# UNITED STATES PATENT AND TRADEMARK OFFICE

APPLICATION NO.	FILING DATE	FIRST NAMED INVENTOR	ATTORNEY DOCKET NO.	CONFIRMATION NO.
10/033,163	10/24/2001	Diane M. Landers	DP-304037 / DE3-0203	7139

# Office Action Summary

### DETAILED ACTION

FIG. 55A

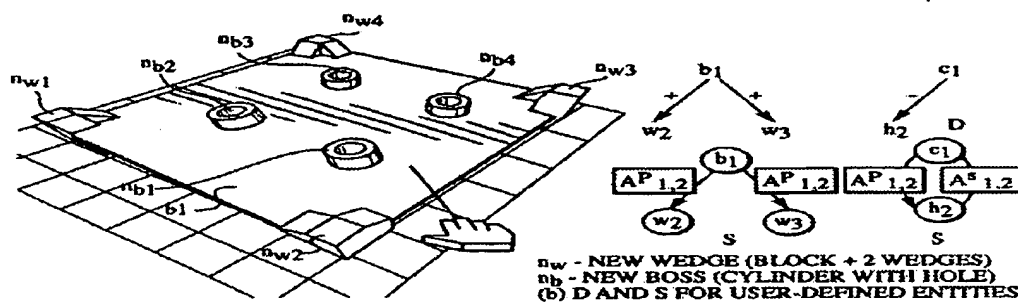
Referring to claims 1, 50, 99, and 122, Gadh clearly teaches a method, system, part, and computer program of horizontally structured CAD/CAM manufacturing for concurrent product and process design (Fig. 55A and 55B; Col. 36, lines 28-39; Col. 8, lines 5-24), comprising: selecting a blank for machining into an actual part establishing a coordinate system (Figs. 10A-10C and corresponding description, i.e., "rubber-banding"); creating a master product and process concurrent model (Col. 10, lines 22-58) comprising: a virtual blank corresponding to said blank (Fig. 55A, element b1); a manufacturing feature (Fig. 55A, any of elements nw or nb); virtual machining of said manufacturing feature into said virtual blank (See Fig. 55A and Col. 36, lines 28-39), said manufacturing feature exhibiting an associative relationship with said coordinate system (See Fig. 25A-25D; Col. 24, lines 6-32).

Gadh clearly teaches a design intent graph (D) used to create a design and record the specified design constraints to be used in future design activities. Clearly, D refers to the intended/desired geometric relations between the models features (Col. 20, lines 56-65). Gadh clearly teaches exemplary embodiments of a "machined part constructed in VDSF" with its corresponding D (Col. 36, lines 28-34).

Clearly, the D depicted above, is horizontally structured. The virtual blank is element  $b_1$ , and a manufacturing feature could clearly be any of  $nw$  or  $nb$  with exclusive relationships to  $b_1$ . Gadh clearly teaches elements as add-ins, wherein, as mentioned above, the figures depict “a machined part constructed in VDSF”. Gadh clearly shows the manufacturing features on a grid coordinate system. Furthermore, Gadh clearly teaches a child element (which can clearly be interpreted, without question, as any of the  $nw$  or  $nb$  elements) has an associative relationship with the coordinate system. The VDSF display viewed by the user is considered as having a right-left/top-bottom/front-rear coordinate system, whereby the user issues intuitive commands for a user-viewpoint-dependent method of alignment of said child element. And, Gadh also clearly teaches that VDSF determines the XYZ coordinate axes when a viewpoint-dependent alignment command is issued (Col. 24, lines 6-32). Furthermore, Gadh teaches the representation can be implemented in any conventional 2D-CAD systems or VR-CAD systems utilizing VE (Col. 39, lines 33-44). Examiner respectfully submits that “associative relationship” requires no further explanation and that it will be given its plain meaning as required by MPEP
